ROCKY FLATS SITE REGULATORY CONTACT RECORD

Purpose: Management of Intercepted Groundwater During SPPTS Repair or Maintenance Activities

Contact Record Approval Date: July 3, 2008

NOTES: Photograph depicts features in the vicinity of the SPPTS and the general area where water will be placed. See text for discussion. SW = surface water; FC = Functional Channel; SPP DG = discharge gallery.

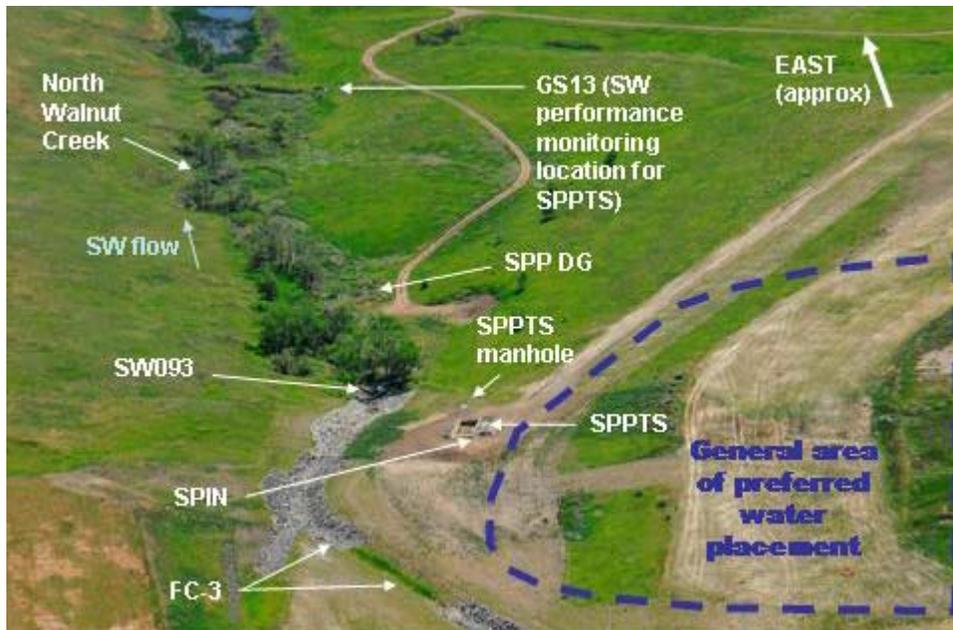
The Solar Ponds Plume Treatment System (SPPTS) includes a groundwater intercept trench from which groundwater is pumped into cells for treatment. The Interceptor Trench System (ITS) is present in the subsurface generally southwest, south, and southeast of the SPPTS groundwater intercept trench. During periods in which the SPPTS is serviced (e.g., media replacement) or modified (as planned in late 2008), intercepted groundwater may need to be otherwise controlled. Previously, groundwater has been allowed to accumulate within the trench in such times. However, there may be instances in which an alternative method of controlling the water is needed, for example if groundwater levels are high or need to be kept lower in the trench.

DOE, CDPHE and S.M. Stoller staff consulted regarding this intercepted water management approach at a meeting on May 6, 2008.

As necessary to support SPPTS maintenance and repair activities, groundwater that is intercepted by the SPPTS intercept trench may be pumped to the ground surface in the area generally southwest and south of the treatment cells, including on the hillside as long as appropriate erosion controls are maintained and the water does not enter North Walnut Creek. Erosion controls will be employed in accordance with the *Erosion Control Plan for Rocky Flats Property Central Operable Unit, DOE-LM/1497-2007*, July 2007. Flow rates will be carefully controlled to minimize muddy conditions, and runoff of the water pumped to the ground surface shall not be allowed to reach FC-4/North Walnut Creek. The attached figure illustrates the general area suggested for placement of this water.
